## **Merged Document Report**

**Application No.: PL8824**

Description :	
Address :	
Record Type :	PLAT

Document Filename
07.14.25 - Final Plat.pdf

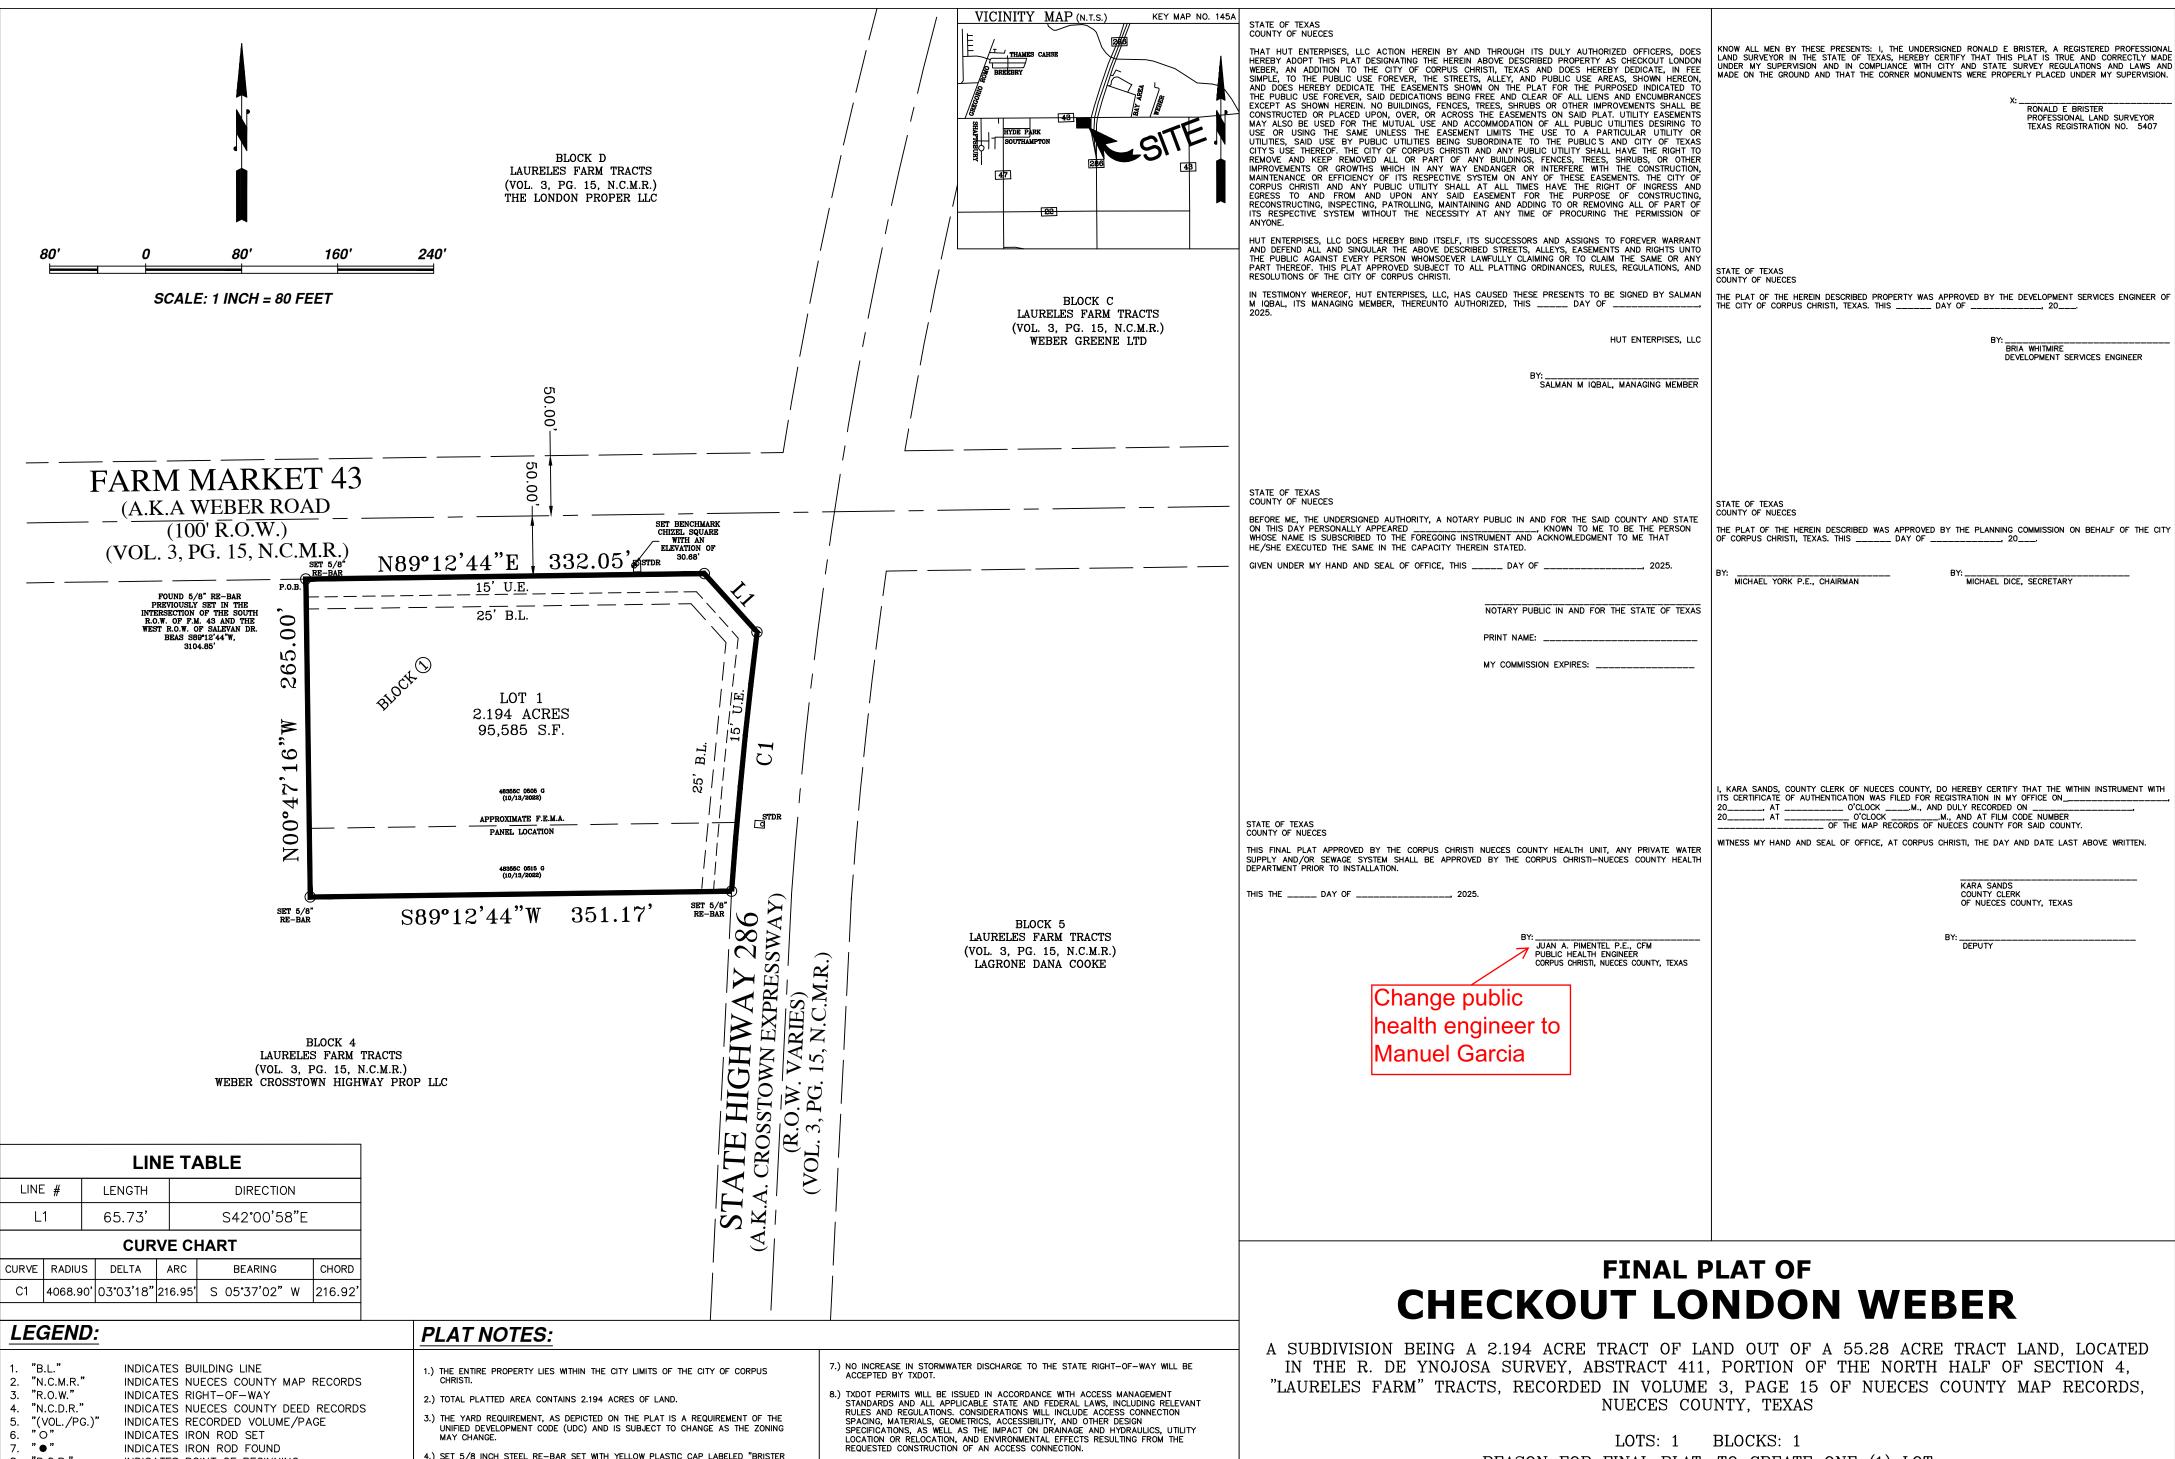
Comment ID	Author : Department	Status	Review Comments	Applicant Response Comments
6	Alex Harmon : DS	Open	Update 7/23: CCW found that the existing (undersized) water line was abandoned as part of the TxDOT project meaning the lot is not served with any water making PIs required prior to plat approval.  Improvements Required for Recordation, per UDC 8.1.4. A. Streets: No Sidewalks: Yes, at site development B. Water: At site development depending on fireflow testing Fire hydrants: At site development C. Wastewater: Yes, unless using septic system as it appears D. Stormwater: No

Comment Author : Department Status		or : Department Status Review Comments A		Applicant Response Comments
			E. Public open space: No F. Permanent monument markers: No	
			Please note, improvements required should be constructed to city standards, found in Article 8 and the IDM.

Comment D	Page Reference	Annotation Type	Author : Department	Status	Review Comments	Applicant Response Comments
3	P001	Callout	Mark Zans : LD	Open	Change public health engineer to Manuel Garcia
